Riley Purgatory Bluff Creek Watershed District Permit Application Review

Permit No: 2024-018

Project: Miller Park Outdoor Courts – The proposed project includes the reconstruction of the sidewalk, basketball courts, and tennis courts, and the addition of pickleball courts. The applicant proposes two infiltration basins and a new storm sewer system to provide stormwater rate control, volume abstraction, and water quality control.

Reviewer: Annie Brunton, EIT and Scott Sobiech, PE, Barr Engineering

TITLE: UTILITY PLAN
SHEET: C3-20

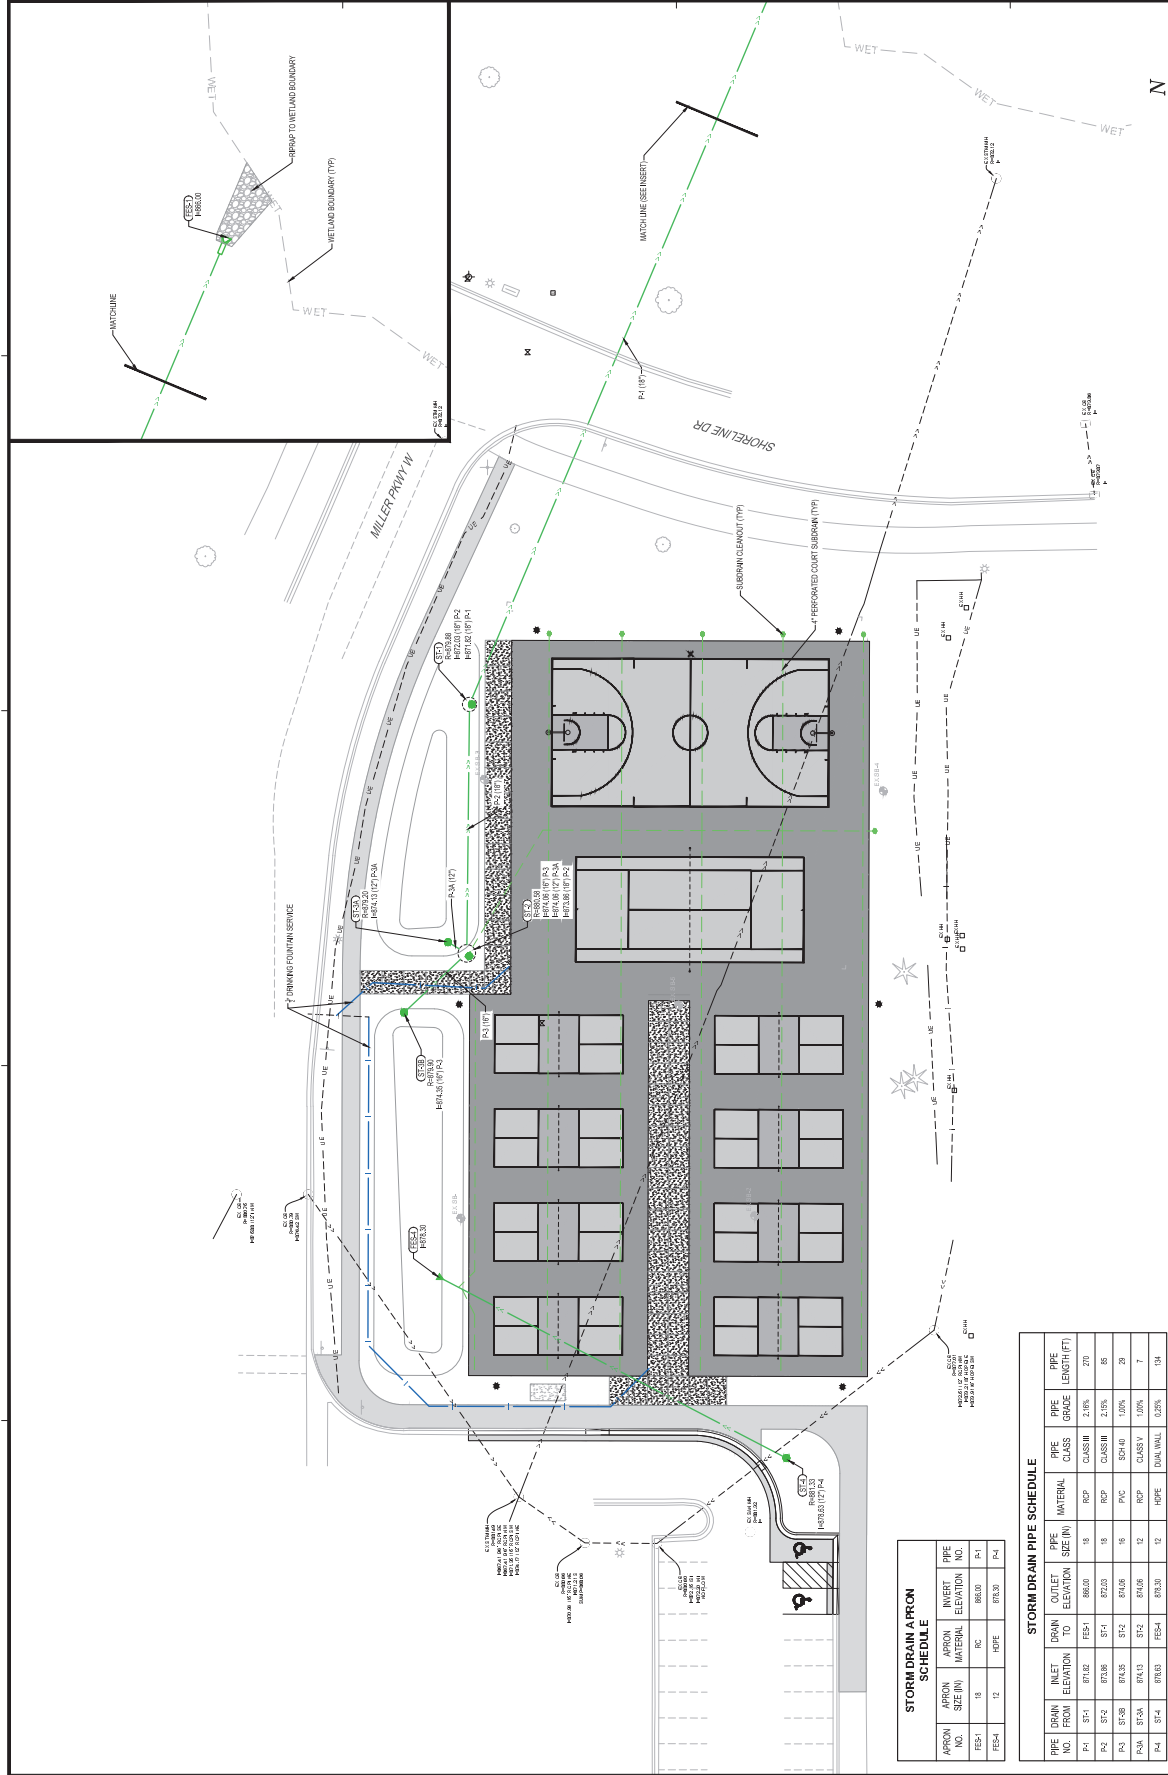
Because the plans show the proposed storm sewer discharging runoff on a slope above the wetland the following revision is needed to conform to RPBCWD Rule C requirements:

- C1. Permit applicant must provide erosion mitigation measures at the storm sewer outfall location upgradient from the wetland, or demonstrate the discharge will not cause erosion between the discharge location and wetland.

1. Receipt of updated plans with erosion mitigation measures at the storm sewer outfall location upgradient from the wetland, or information demonstrating the discharge will not cause erosion between the discharge location and wetland.
2. Because RPBCWD and Eden Prairie have entered into a programmatic maintenance agreement covering typical city projects, the stormwater management facilities associated with this permit (2024-018) must be incorporated into the inventory of those managed in accordance with the programmatic agreement.
